APPLICATION FOR PERMISSION  
UNDER SECTION 16 OF  
THE TOWN PLANNING ORDINANCE  
(CAP.131)

**Proposed Shop and Services (Fast Food Shop) Use  
on the Ground Floor of No. 5, Wang Kong Tsuen, Sai Kung, New Territories  
- Section 16 Planning Application -**

**- Section 16 Planning Application No. A/SK-PK/264 -  
(Further Information No. 1)**

**Proposed Shop and Services (Fast Food Shop) Use  
on G/F, No. 5 Wang Kong Tsuen, Lot 278 (Part) in D.D. 221, Sai Kung, NT.  
- Section 16 Planning Application No. A/SK-PK/264 -  
(Further Information No. 2)**

PLANNING LIMITED 規劃顧問有限公司	<b>LOCATION PLAN</b>	Proposed Shop and Services (Fast Food Shop) Use on the Ground Floor of No. 5, Wang Kong Tsuen, Sai Kung, New Territories
Date: 4 May 2021

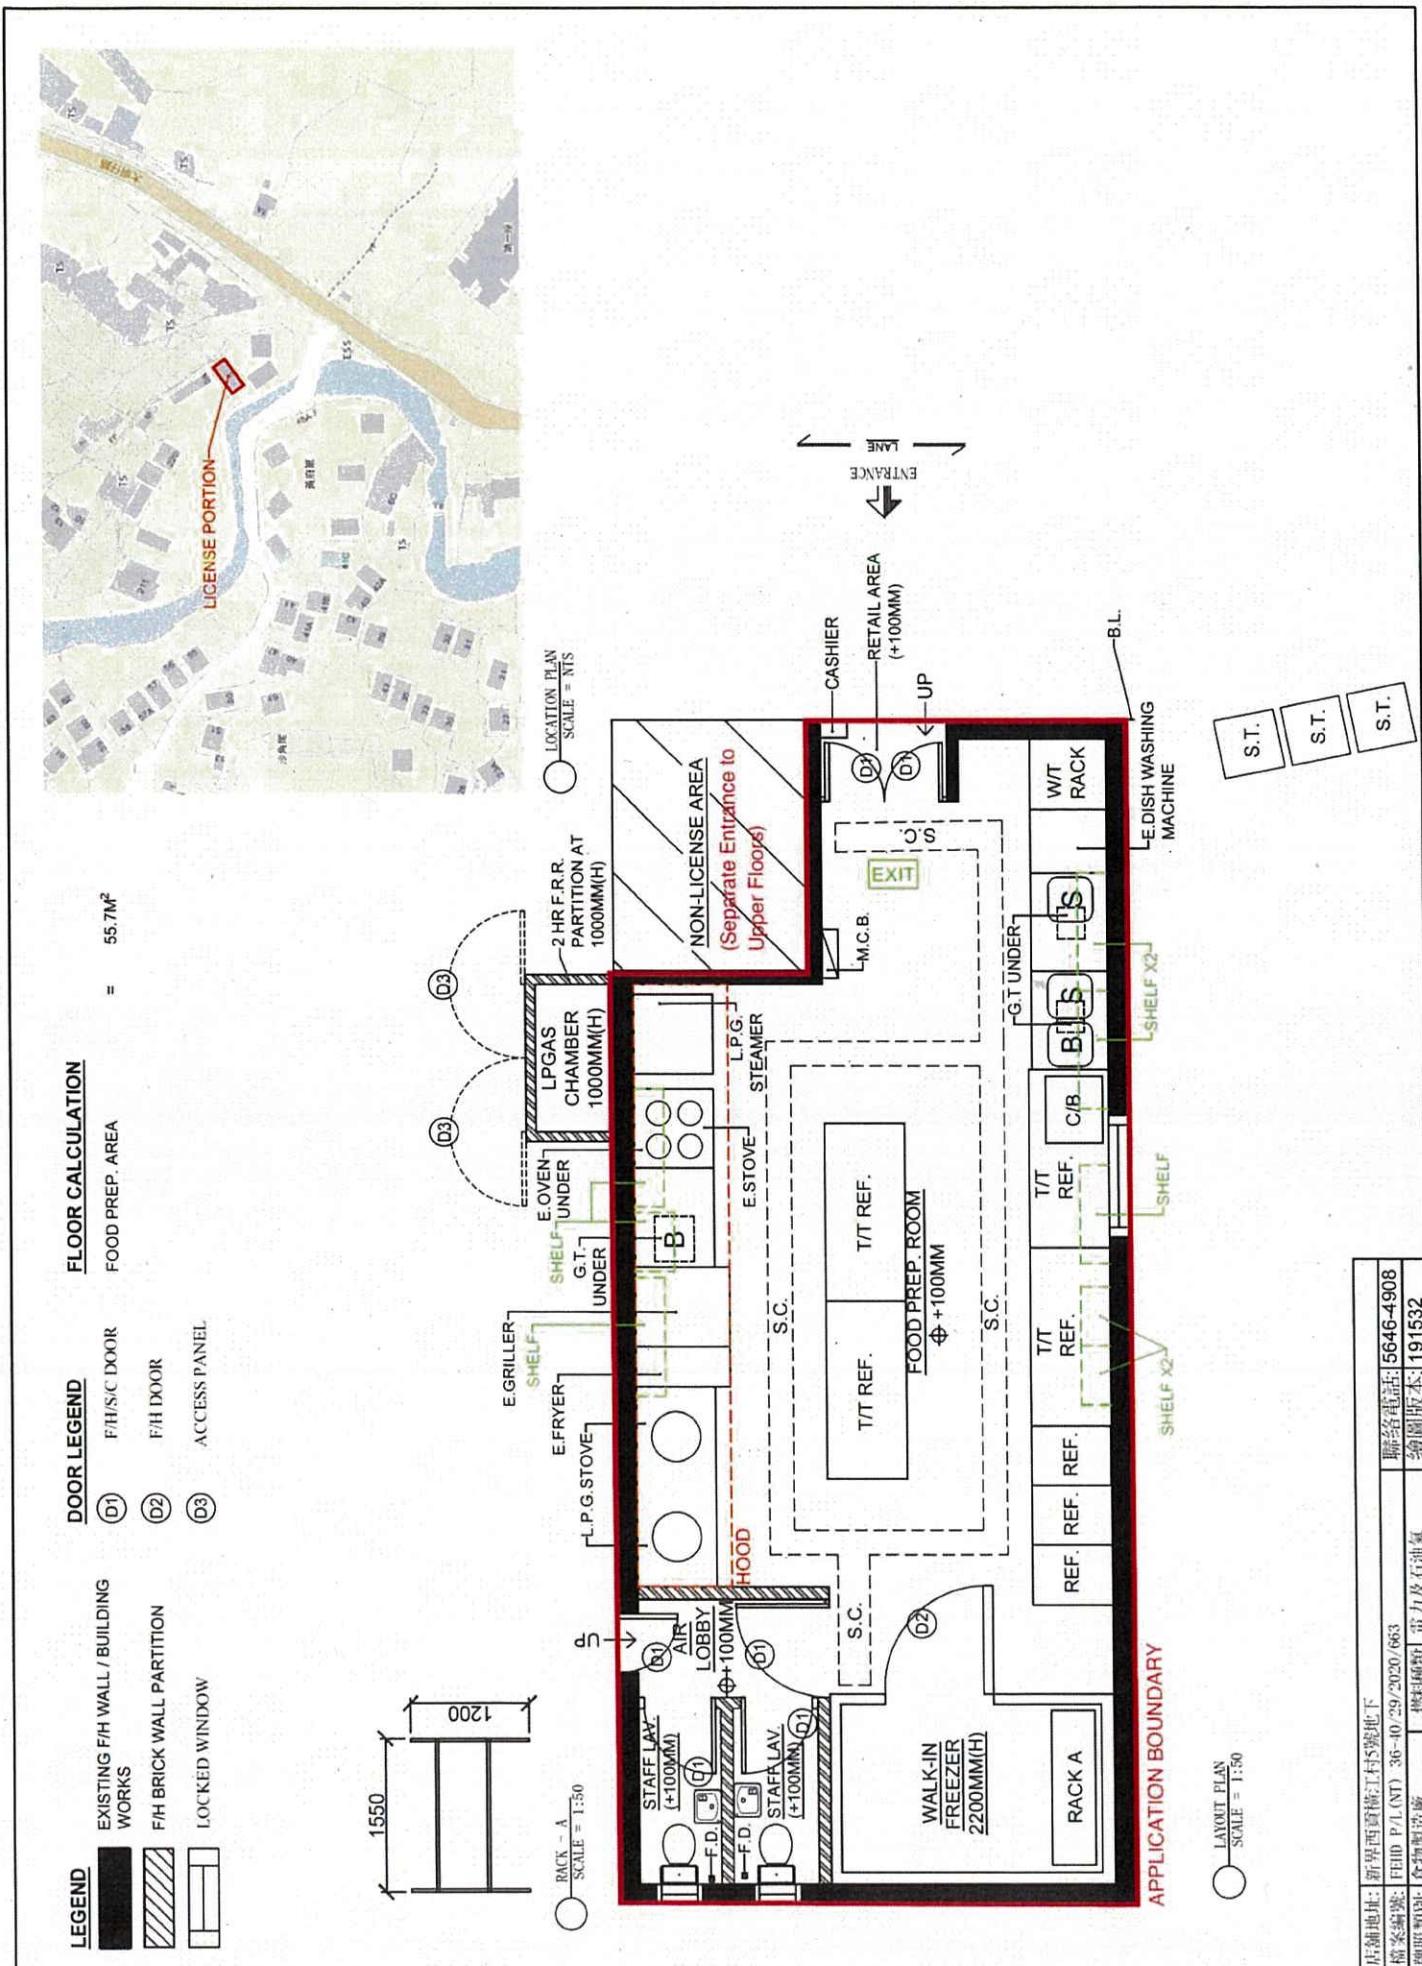
We wish to clarify that the Application Boundary does not cover the "non-licence area", which is the separate entrance to the upper floors on the submitted Layout Plan. Please find enclosed a revised Location Plan to rectify the Application Boundary and a revised Layout Plan with clear demarcation of the Application Boundary for your consideration. The revised pages for Executive Summary and page 7 of the Supporting Planning Statement are also enclosed to amend some typos for your consideration.

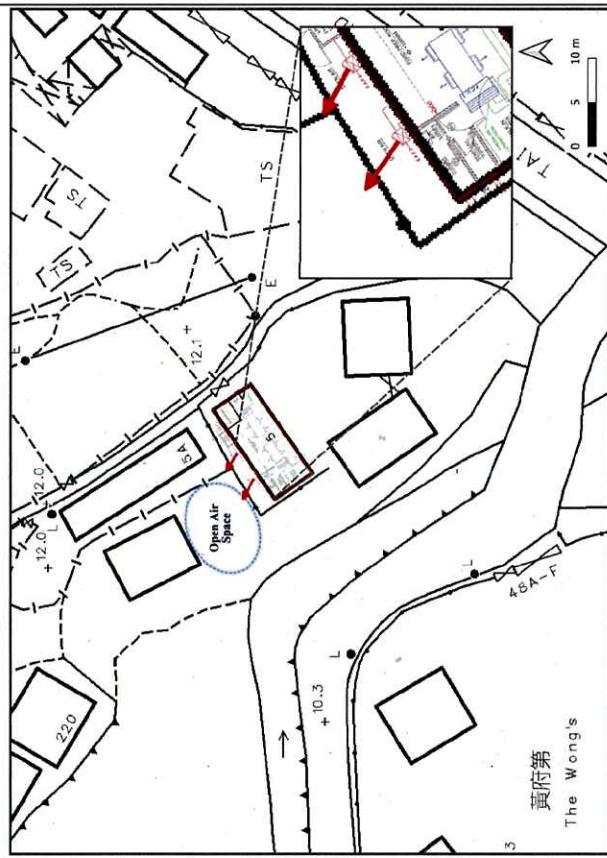
| <p>1. Please clarify if the Guidelines should read as "Control of Oily Fume and Cooking Odour from Restaurants and Food Business".</p> <p>2. Please elaborate explicitly the measures taken/to be taken, e.g. the positioning of exhaust outlets and provision of oily fume/cooking odor control equipment, to demonstrate that the recommendations given in the Guidelines on Control of Oily Fume and Cooking Odour from Restaurants and Food Business are fulfilled.</p> | <p>To clarify, the term 'Guidelines' in the Planning Statement refers to "Control of Oily Fume and Cooking Odour from Restaurants and Food Business"</p> <p>As highlighted in the <b>photo below</b>, the proposed Fast Food Shop is designed with a proper stainless-steel exhaust hood with vents. The exhaust hood is equipped with stainless-steel forefront grease pre-filters (baffle and mesh), which collects grease and provides maximum efficiency of air supply plenum. Electrostatic precipitator will also be installed to remove fine particles in the fume to be expelled via the exhaust.</p>  |

In regards to the exhaust outlets, the exhaust is carefully tilted toward northwest over an open air space. There will be no exhaust direct onto the village house to the northwest of the Proposed Fast Food Shop. Please refer to the plan below.

**Annex A:** Layout Plan of the Proposed Fast Food Shop with exhaust fans and the Specification of the exhaust fans

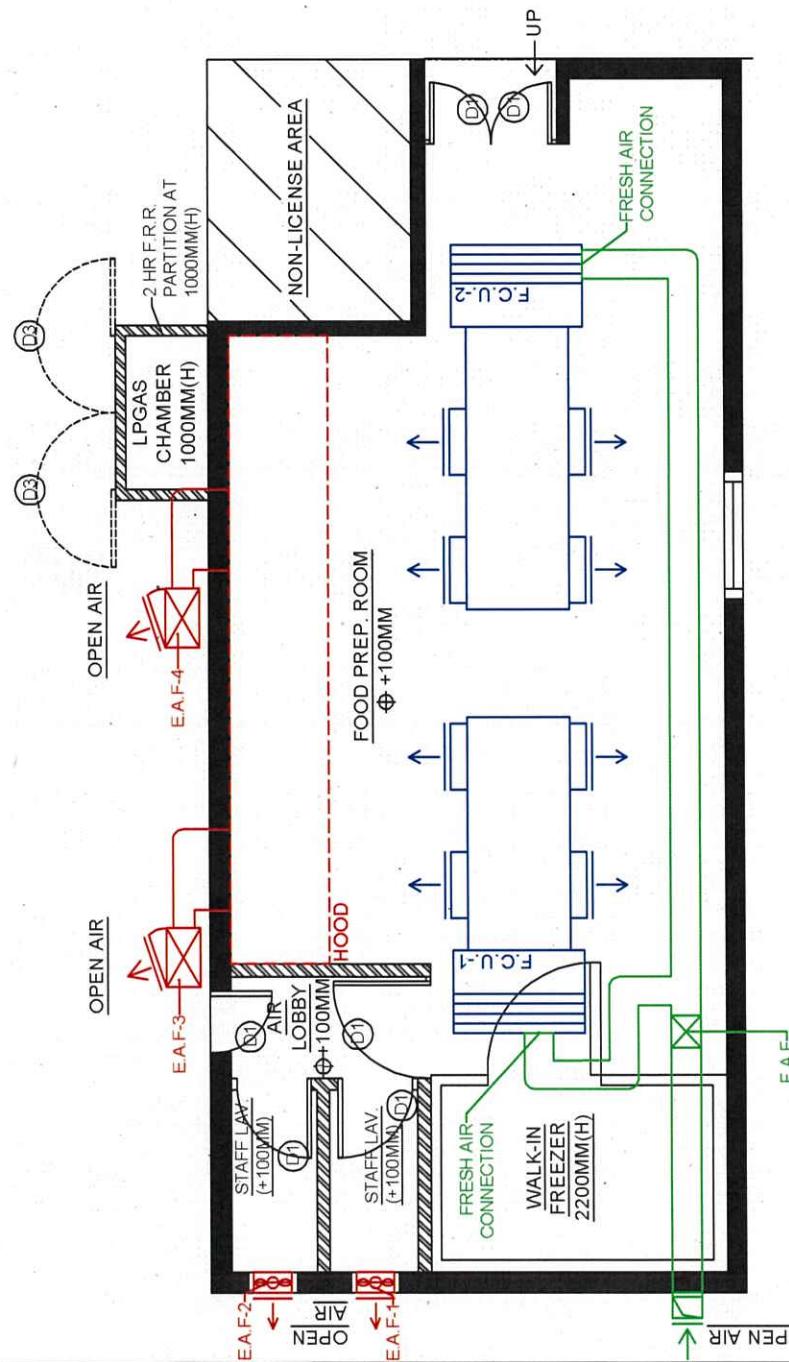
- Noise**
- Given the proposed fast food shop is situated at Ground Floor of the residential village house, noise emanated from the operation of the fast food shop would cause concern from the residents of the residential units above as well as nearby village houses. Therefore, the applicant shall quantitatively address the noise impact arising from the operation of the proposed fast food shop on the surrounding noise sensitive receivers (NSRs), including the residential units above and nearby village houses, in particular, the noise from its fixed noise sources such as kitchen exhaust(s) and ventilating system(s), etc. Also, the applicant shall clarify that whether the proposed fast food shop will have any outdoor seating areas in the

Referring to the layout plan of the proposed fast food shop (**Annex A** refers), the fan for air intake (F.A.F) is within the building and the noise from it will be contained. The exhaust fans E.A.F-1 and E.A.F-2 are ordinarily house type and the noise level from them can be ignored. The exhaust fans E.A.F-3 and E.A.F-4 are industrial type the Panasonic Mini Sirocco Fan FV-19CG1H is installed. The specification of FV-

19CG1H (**Annex A** refers) show the source sound level is only 52.5 dB(A). Accordingly, two operating units of FV-19CG1H will not lead to exceedances of the ANL to any nearby NSR.

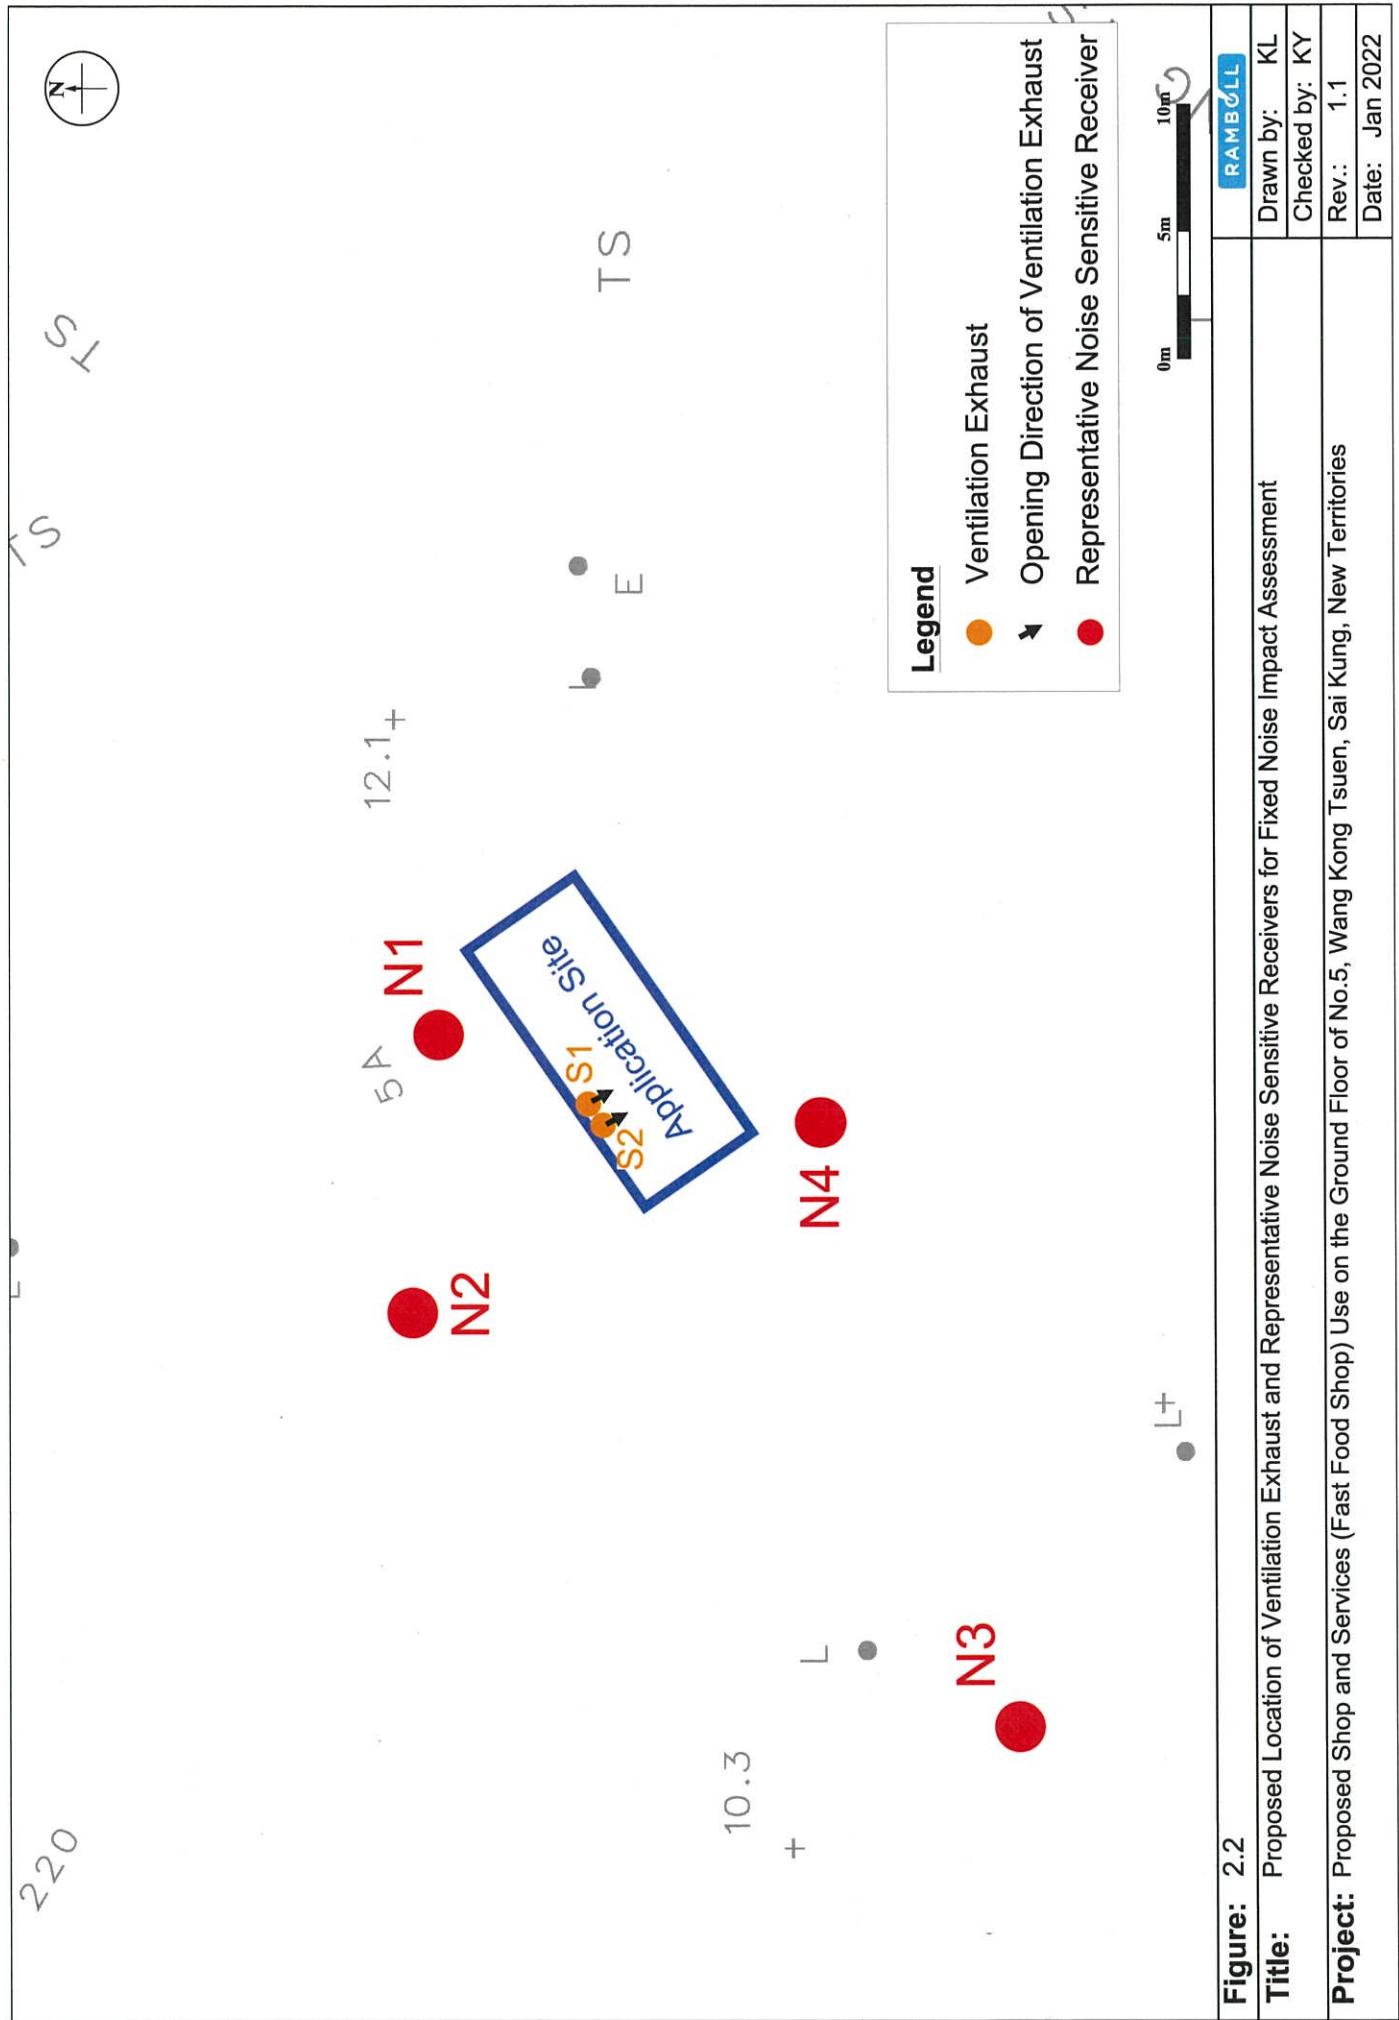
4. Nevertheless, please advise the applicant of our technical comments on the F1 in Annex I.	Noted.	
Annex I		
Noise		
1. NIA Report (Figure 2.2) in Annex A of RtC- The figure number of drawing title "Proposed Location of Ventilation Exhaust and Representative Noise Sensitive Receivers for Fixed Noise Impact Assessment" is missing and it should be Figure 2.2.	Figure number for Figure 2.2 has been provided.

Enclosed  
Annex A: Replacement pages of NIA Report
